**REPORTS,
FINDINGS AND
RECOMMENDATIONS**

**ALASKA POWER AUTHORITY
EXTERNAL REVIEW PANEL
SUSITNA HYDROELECTRIC PROJECT**

APRIL, 1982

REPORT NO. 1

FIGURE I

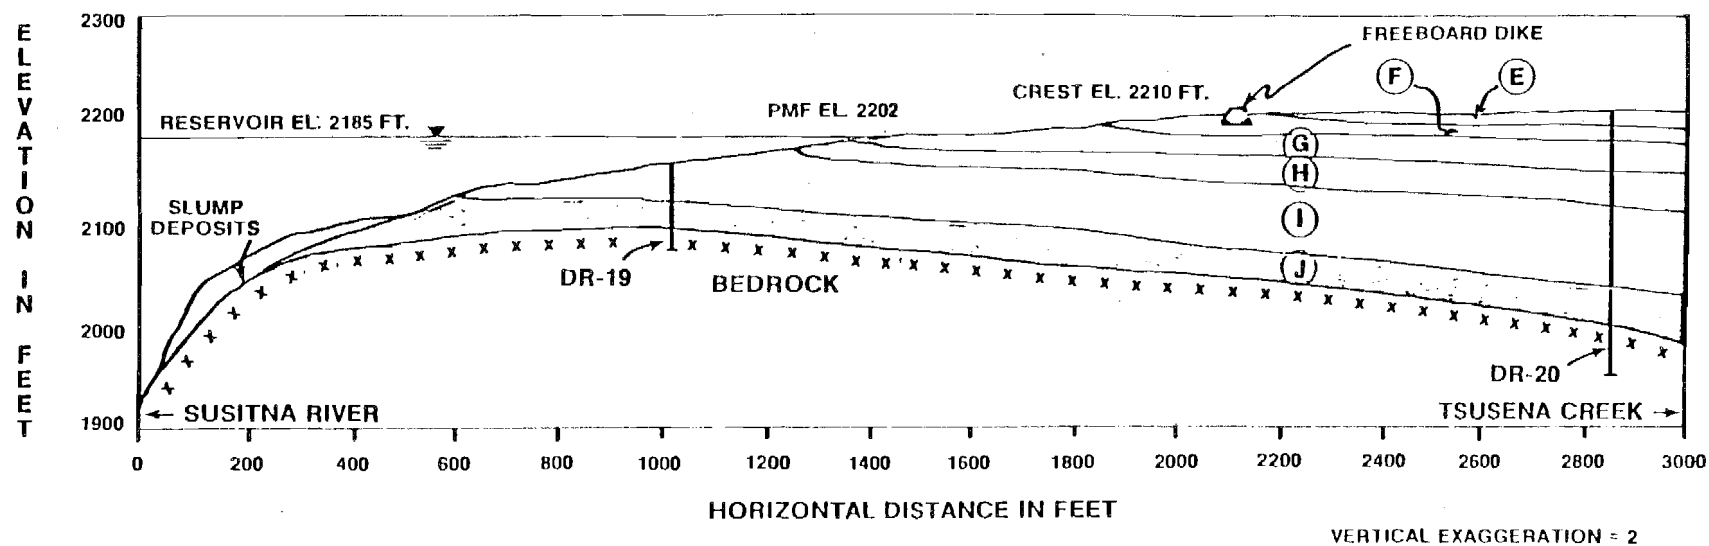
Recently, the possibility of liquefaction of the uppermost layers of the buried channel fillings has been raised. If these materials liquified, and if large volumes of these materials could move under the gentle slopes shown in attached section W-16 of Figure 6.34, Task 5 Report; then it would be hypothetically possible to breach the reservoir. Recent stratigraphy has been developed for the buried channel which is shown in attached Figure 1. As shown in Fig. 1, the lower unit K is the buried alluvium, unit J is a preloaded till, unit J1 is an interglacial alluvium, unit I is a preloaded till, unit H is an alluvium, unit G is a waterlain till or lucustrine deposit, and units A,B,C,D,E and F are more recent outwash deposits. It is highly unlikely that liquefaction could be a problem from the top of unit I downward as shown in the cross section given in Figure 2.

FIGURE 2

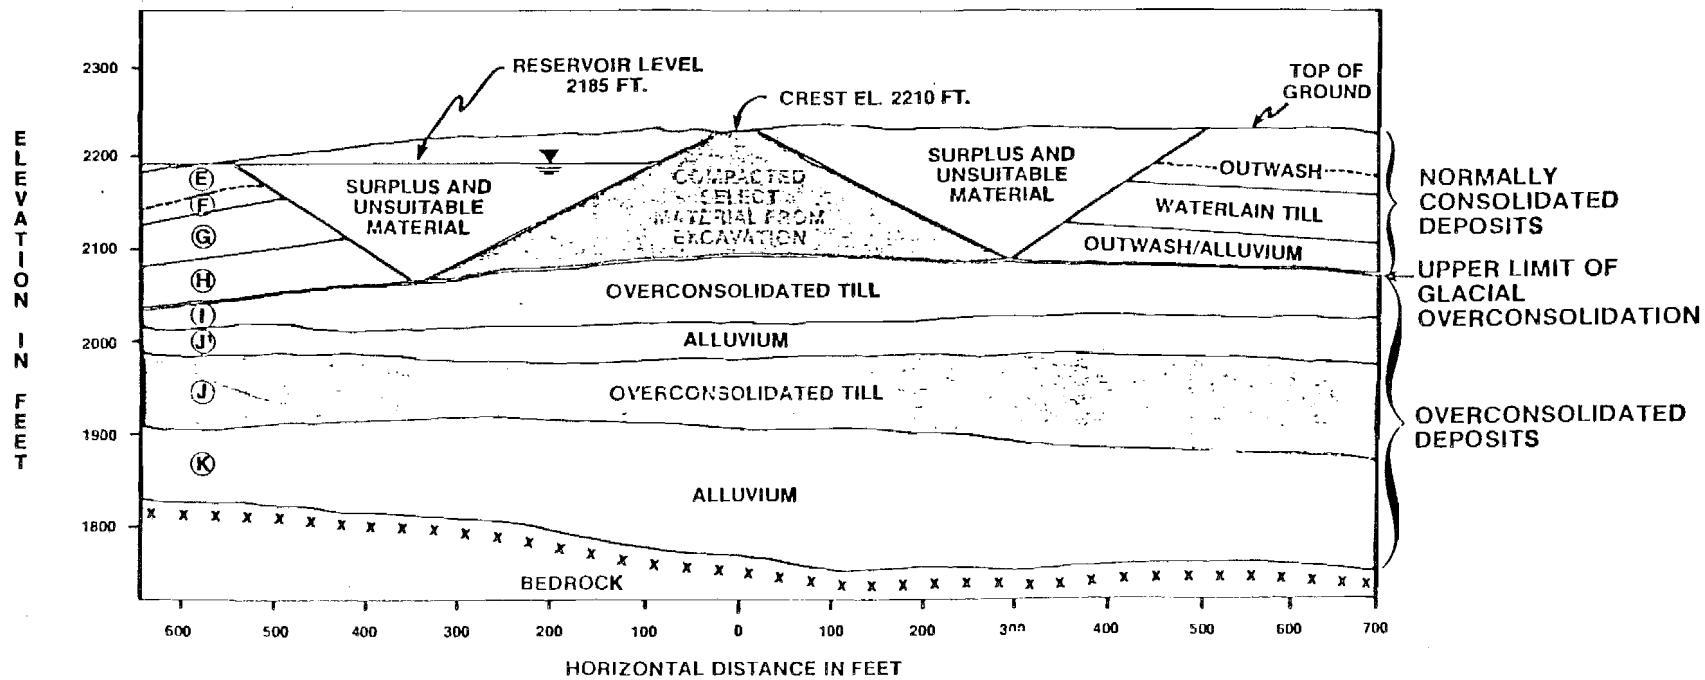
The alluvium in stratum H will be saturated by the reservoir, however, and more information is needed to conclude whether liquefaction is or is not a problem in stratum H. Stratum H is buried beneath the water laid till unit G, which indicates it was saturated under the water levels which produced unit G and was probably subjected to earthquakes during that time period. Further development of the pleistocene geology may clarify this point. The strata above unit G are outwash materials and more information is required on density, gradations, and blow counts in order to make definite comments
